EMERGENCY AIRWORTHINESS DIRECTIVE

Number: G-2021-0010-E

ATA 28 – Fuel –Cylinder Quick Shut-off Valve Mounting Flange – Inspection / Replacement

Figure 1: *CB437 Flanged Adaptors for Quick Shut-Off (QSO) valves*

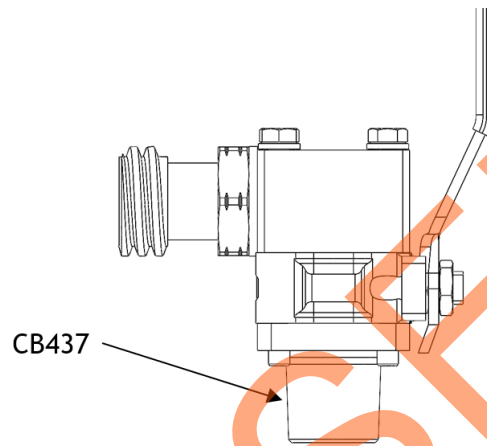
Certain Cameron Hot Air Balloon fuel cylinders are supplied with liquid offtakes that consist of a quarter turn ball valve mounted on a flanged adaptor (P/N CB437, see figure 1). Two recent batches of these adaptors have been manufactured with non-conforming (undersize) threads.

In certain cases, when the minimum sized adaptors are combined with cylinder bosses at maximum tolerance dimension and assembled to fuel cylinders, the thread can impinge (“bottom out”) on the cylinder boss. Although the required tightening torque value can be achieved at installation, the torque required to unscrew the flange could be below the minimum value. In extreme cases the adaptor may be unscrewed by hand.

4. From the effective date of this AD, do not install an affected part on any cylinder.
5. Within 4 months after the effective date of this AD, modify each cylinder by replacing the P/N CB437 issue F QSO flanged Adaptor, with a P/N CB437 issue G (or later issue) QSO flanged adaptor in accordance with the instructions of the SB, or by replacing the QSO valve assembly with a handwheel valve part No CB0824-0001 (this part has a Rego-type hose connection).
